Access Compliance Report

Public Rights-of-Way

(Curb Ramps)

Intersection ID: 10029862	Main Street: KUYKENDALL_RD	Cross Street: N/A	Location: SE
ADA ID: 0182FBB967A7	Ramp Type: BlendTrans1	Initial Pass/Fail: Fail	Overall Compliance: No
Severity Score: 12.5			
Codes/Mitigation Info/Possible Solution		Field Measurements/Component Compliance

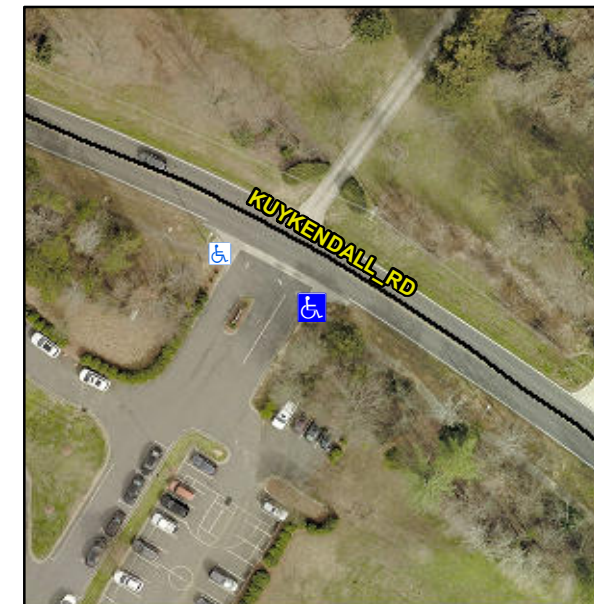
Compliance	Description	Data	Compliance	Description	Data
N/A	Ramp Length (in)	58.0	Yes	BlendTrans Slope (%)	2.7
Yes	Ramp Width (in)	48.0	No	BlendTrans XSlope (%)	6.6
N/A	Flare Type LT	N/A	N/A	Flare Type RT	N/A
N/A	Flare Slope LT (%)	N/A	N/A	Flare Slope RT (%)	N/A
N/A	Flare Traversable LT?	N/A	N/A	Flare Traversable RT?	N/A
N/A	Landing Length (in)	N/A	N/A	DWS Provided?	N/A
N/A	Landing Width (in)	N/A	N/A	DWS Contrast?	N/A
N/A	Landing Slope (%)	N/A	N/A	DWS Length (in)	N/A
N/A	Landing X Slope (%)	N/A	N/A	DWS Full Width?	N/A
N/A	Landing Curb? (Y/N)	N/A	N/A	DWS Offset (in)	N/A
N/A	Shared Landing?	N/A			
N/A	Gutter Ponding?	N/A	N/A	Gutter Slope (%)	N/A
N/A	Gutter Lip Ht (in)	N/A	N/A	Gutter X Slope (%)	N/A
N/A	Painted X Walk1?	No	N/A	Painted X Walk2?	No
	X Walk 1 Direction	To NE		X Walk 2 Direction	To NW
	X Walk 1 Width (in)	N/A		X Walk 2 Width (in)	N/A
	X Walk 1 Slope (%)	5.2		X Walk 2 Slope (%)	2.0
	X Walk 1 X Slope (%)	1.1		X Walk 2 X Slope (%)	9.3

N/A	Ramp inside XWalk1?	N/A	N/A	Ramp inside XWalk2?	N/A
	Road Slope (%)	5.8		Clear Space?	N/A
	Road X Slope (%)	3.3	N/A	Clear Space to XWalk (in)	N/A
N/A	Any Obstructions?	N/A	N/A	Storm Grate/Utility Hazard?	N/A
	Obstruction Type			Storm Grate/Utility Type	
		N/A			N/A
			Yes	Surface Condition? (G/P)	Good
			N/A	Curb Slope (%)	2.7

Remove & Replace Curb Ramp With Two New Directional Ramps or Equivalent.

R304.5.3
